ADDENDUM NO. 1

**Annual Street Resurfacing & Preventative Maintenance
Project No. 25503**

ANNUAL STREETS RESURFACING AND PREVENTATIVE MAINTENANCE PROJECT - CIP NO. 25503
APRIL 2025

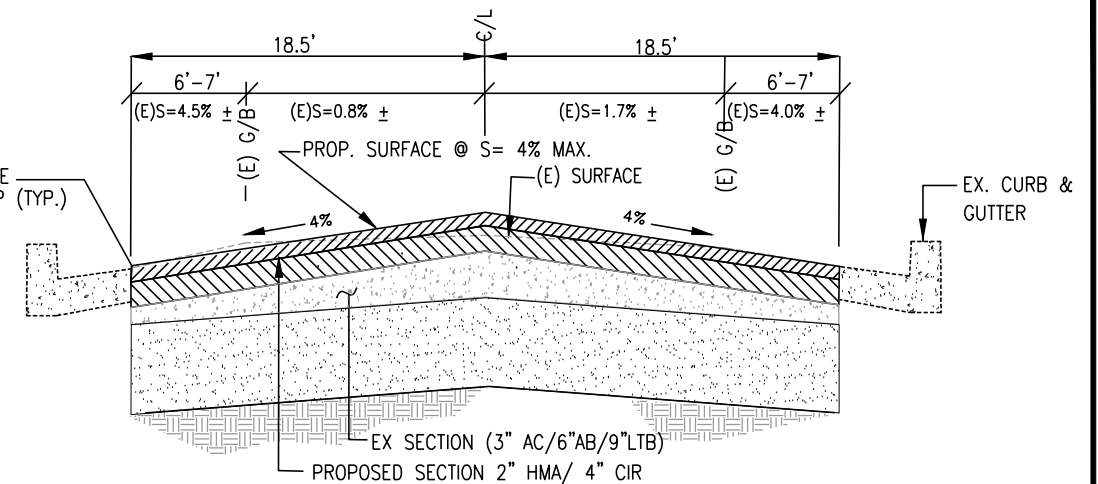
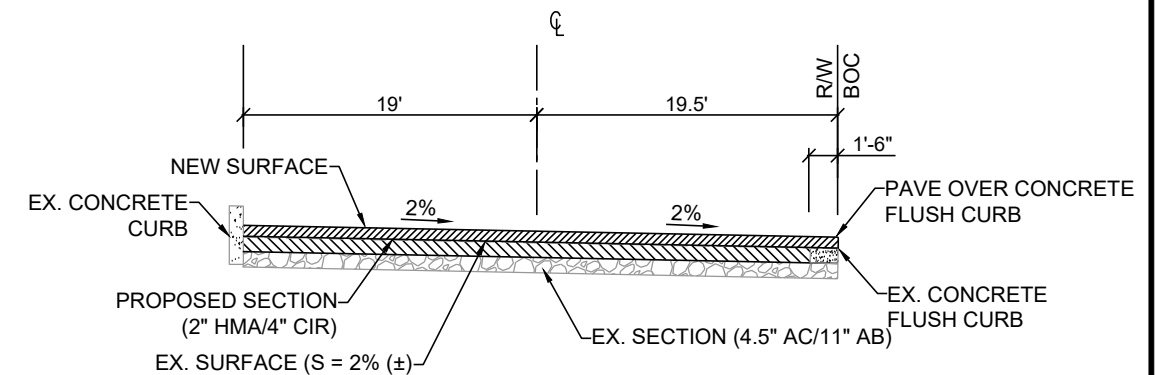
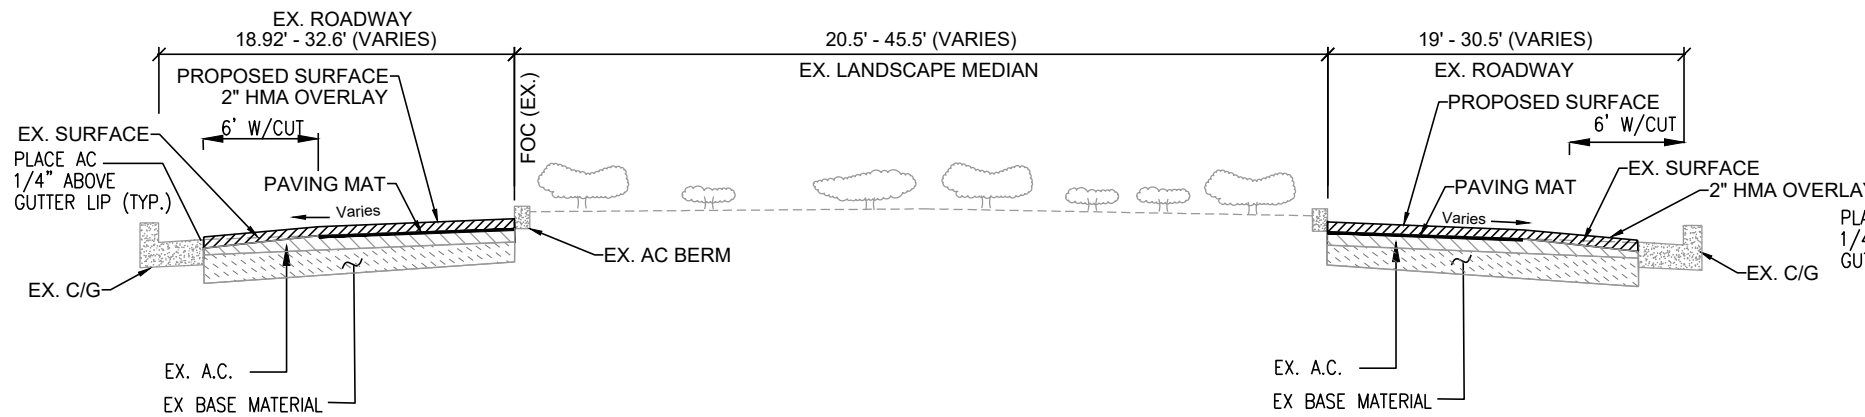
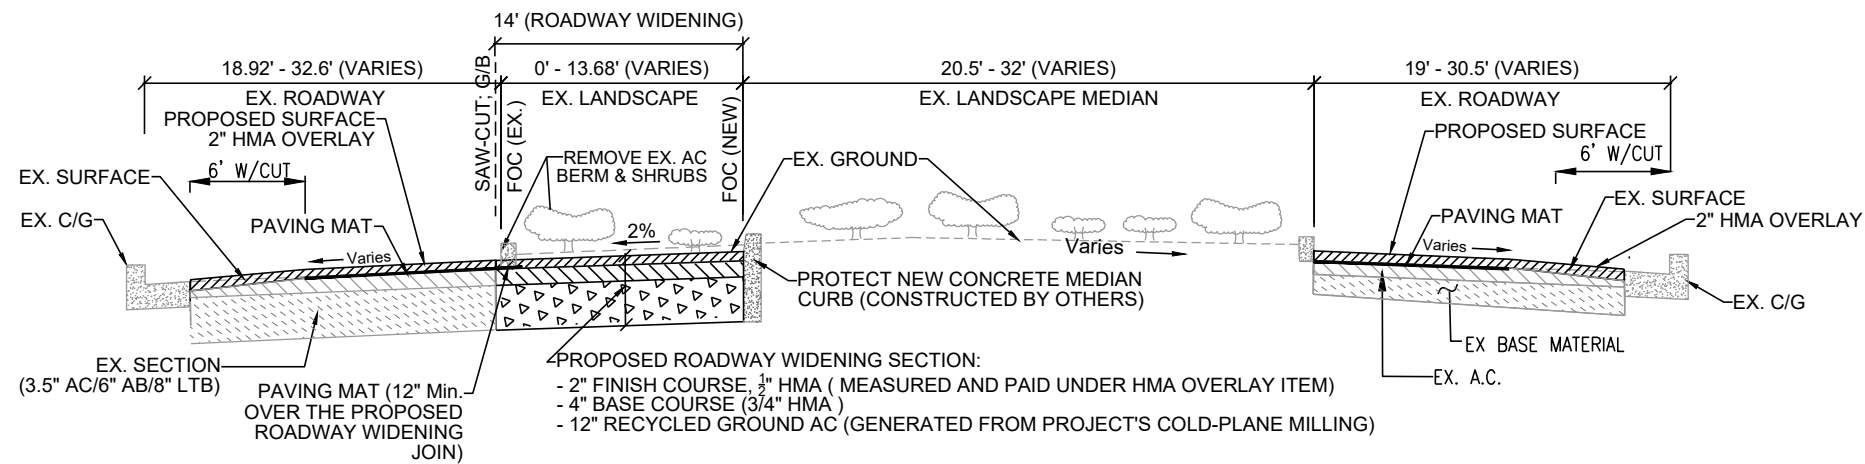
- 9) Replace plan sheet DWG No. G-3 & DWG No. G-4 with G-3R & G-4R to reflect changes per Item #1 & 2 above.
- 10) Replace plan sheet DWG No. D-2 (ALT. A) and DWG No. D-2 (ALT.B) with D-2R (ALT. A) AND D-2R (ALT. B) for printing production clarity.

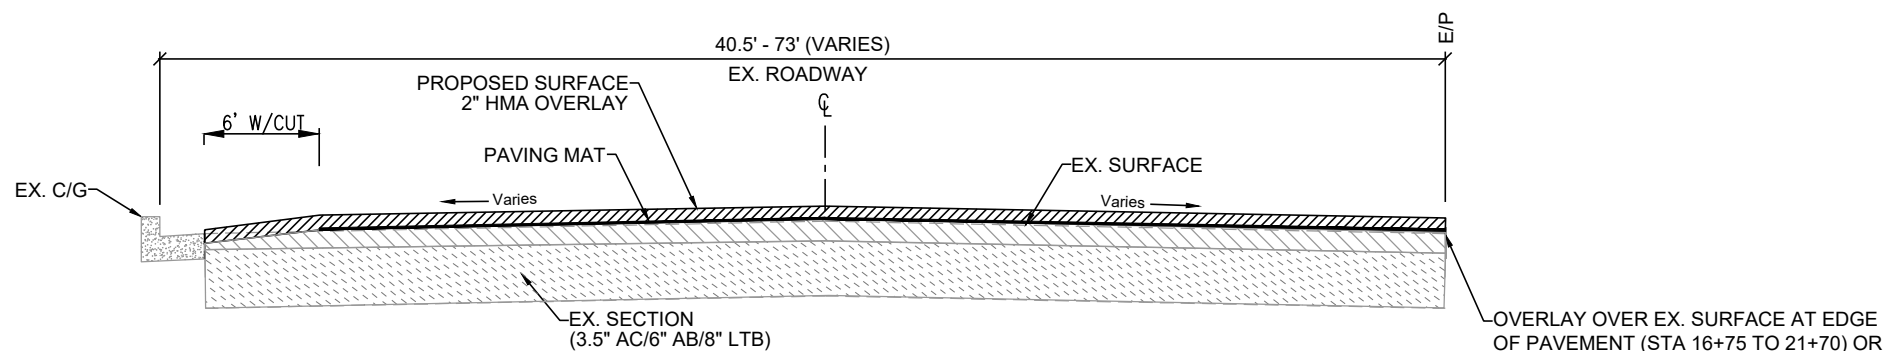
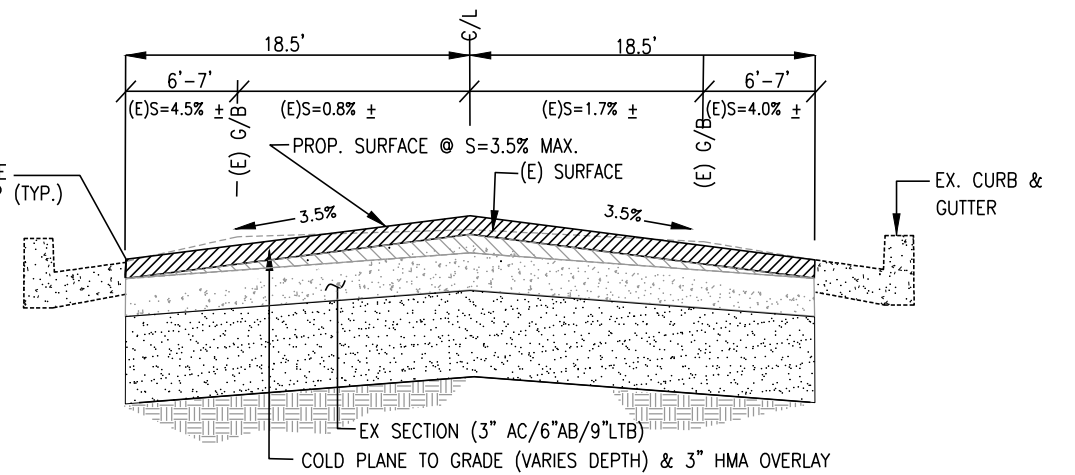
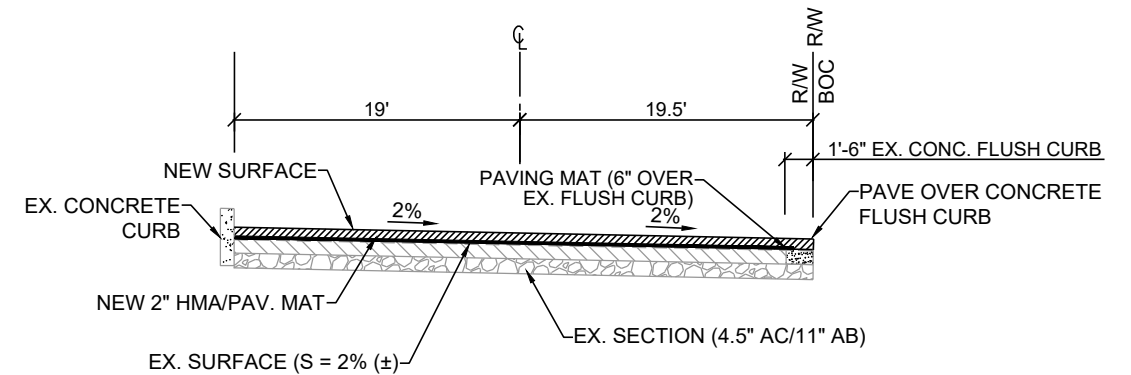
- h) On W. Las Positas Blvd. for Bid Alternative B, plan sheets 10 & 12, the streets resurfacing is hatched as Mill/Cold-Plane and Overlay, but in the Construction Details on plan sheet 8 show the proposed surface as just 2" HMA Overlay with a 6' wedge cut. Please clarify which operation is being done on this street and correct the plan sheets.

- Treatment for W. Las Positas, Alt. B is HMA overlay with Fabric. See Item #12 above.

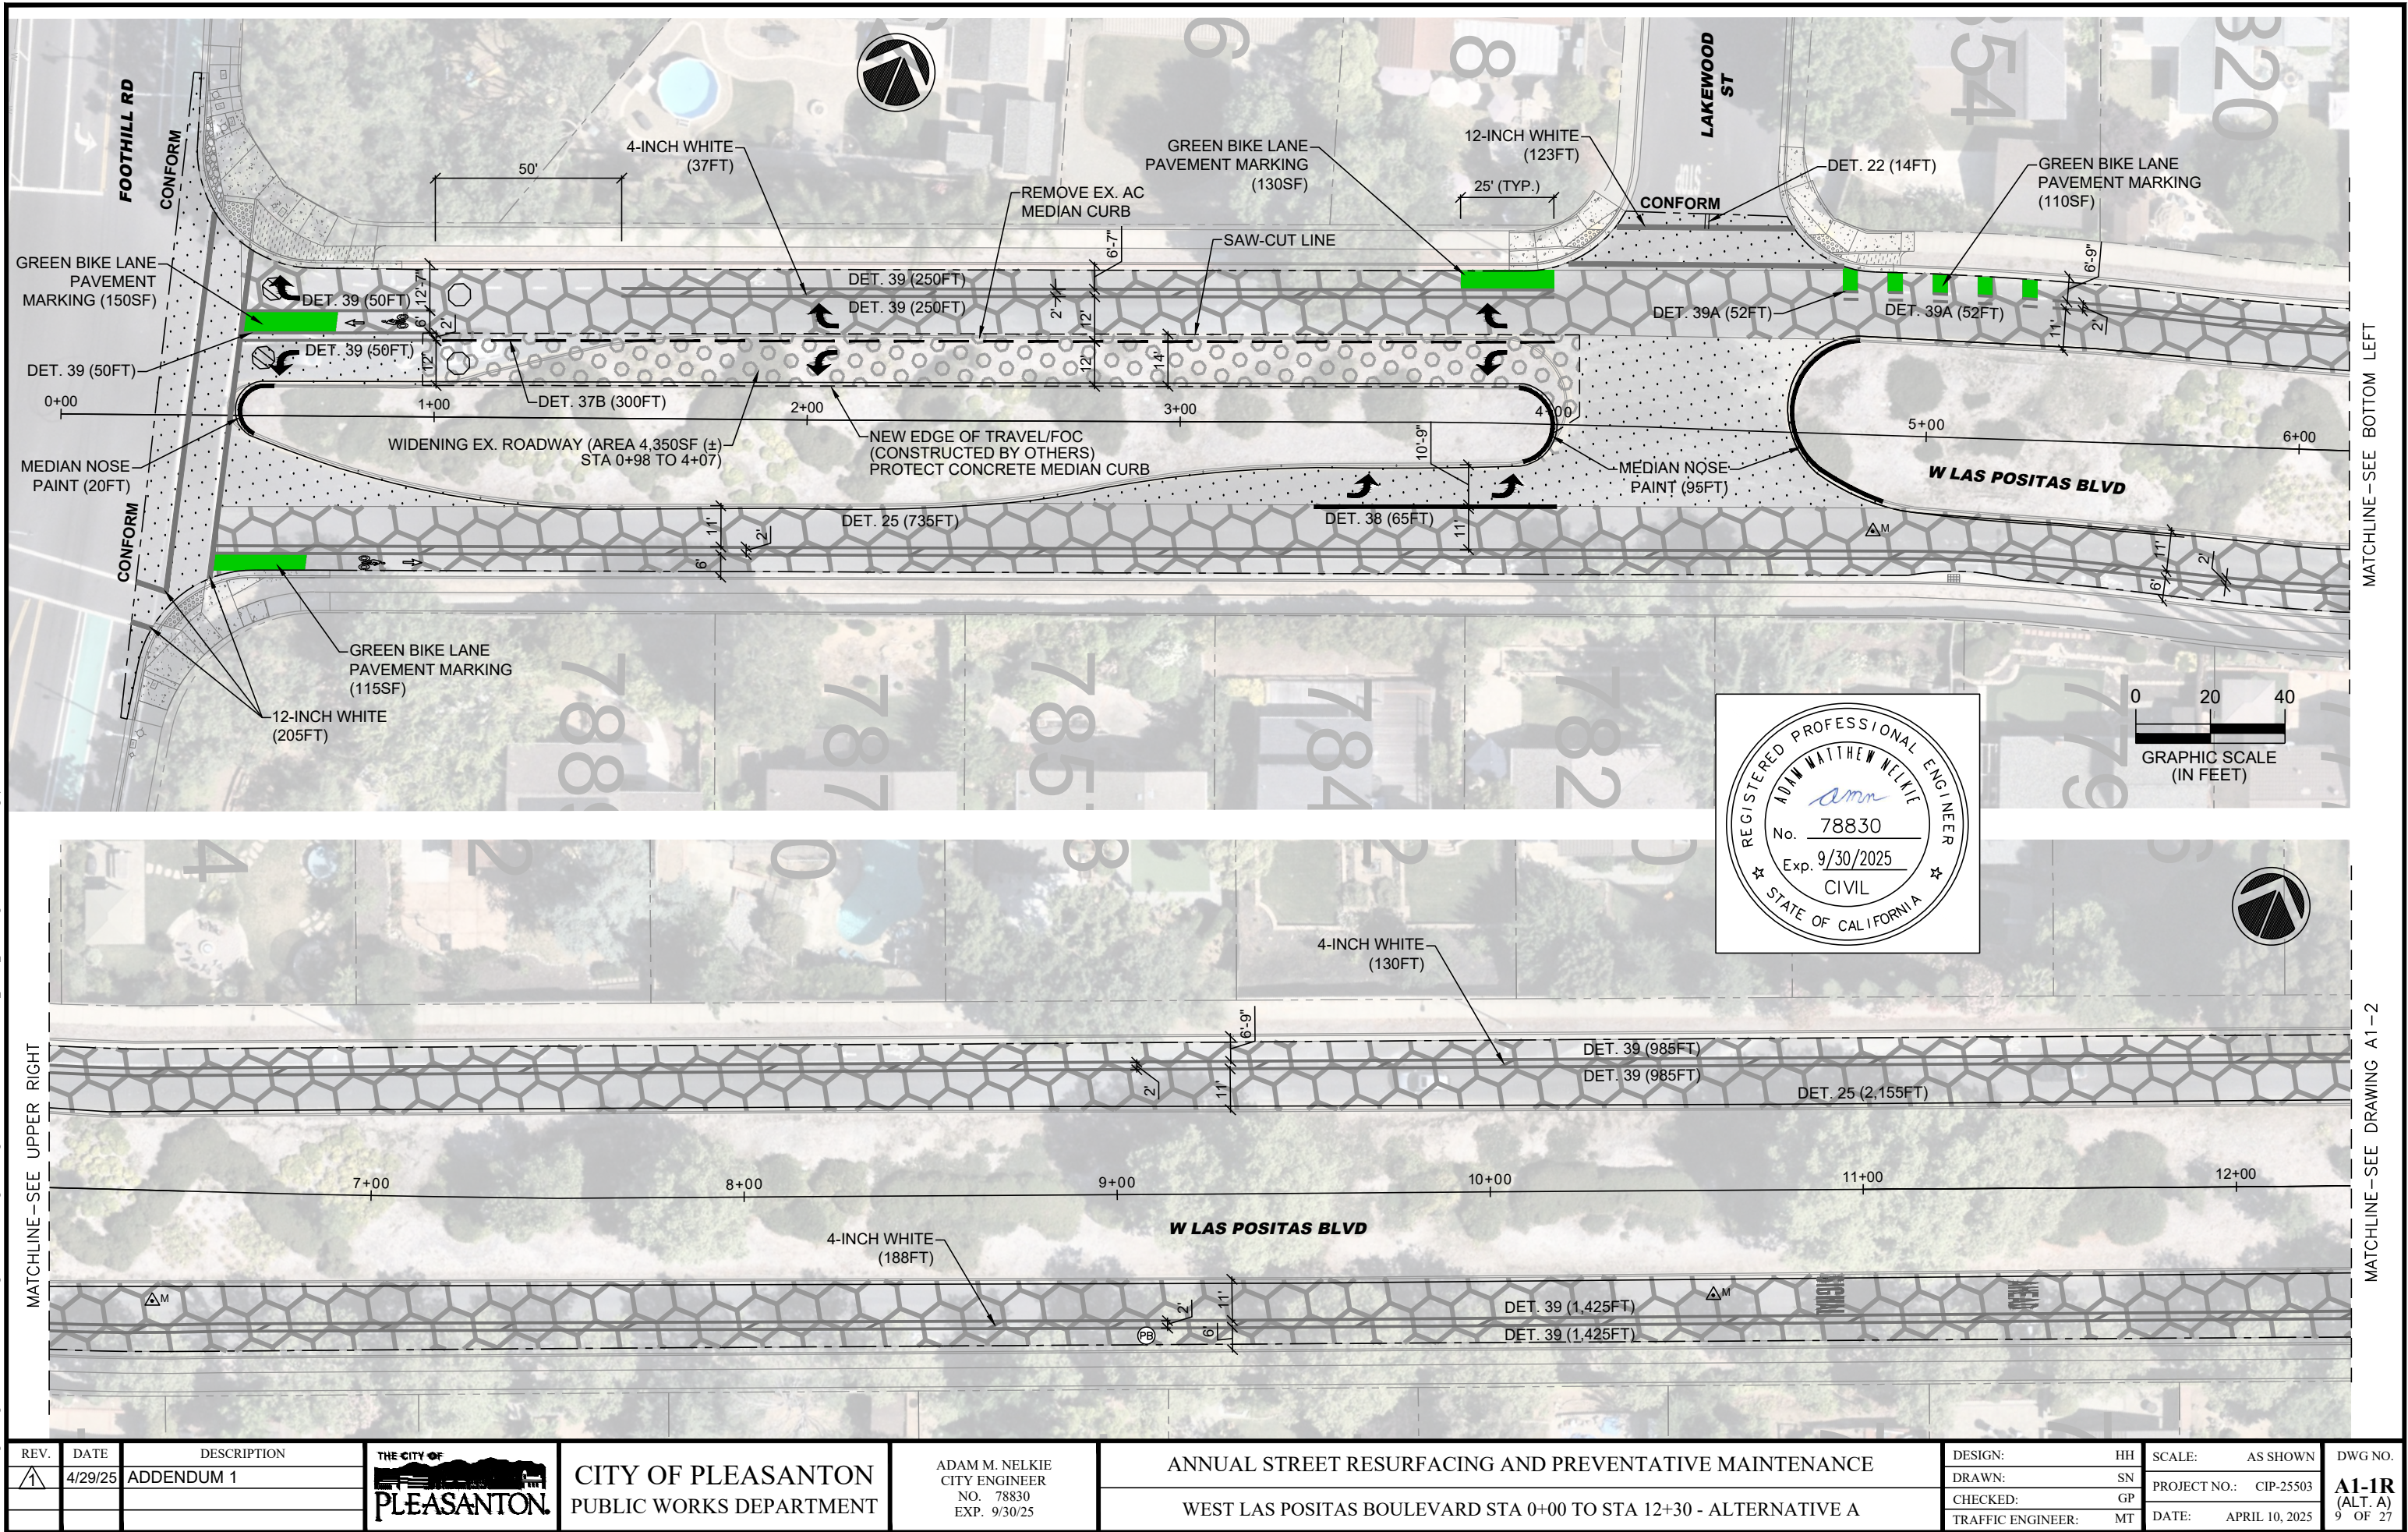
- 11) Replace plan sheet DWG No. A1-1 (ALT. A) and DWG No. A1-2 (ALT. A) with A1-1R (ALT. A) and A1-2R (ALT.A) for striping changes.
- 12) Replace plan sheet DWG No. A1-1 (ALT. B) and DWG No. A1-2 (ALT. B) with A1-1R (ALT. B) and A1-2R (ALT.B) for striping changes and to correct hatching called-out (HMA Overlay with Fabric instead of mill/cold plane & overlay).
- 13) Replace plan sheet DWG No. A6-1 (ALT. B) with DWG No. A6-1R (ALT. B) to correct text called-out “2” HMA OL with Paving Mat” instead of “4” CIR/2” OL.”
- 14) Replace second and third paragraphs of Section 23-01K, West Las Positas Widening, page 75, of the Project’s Special Provisions with
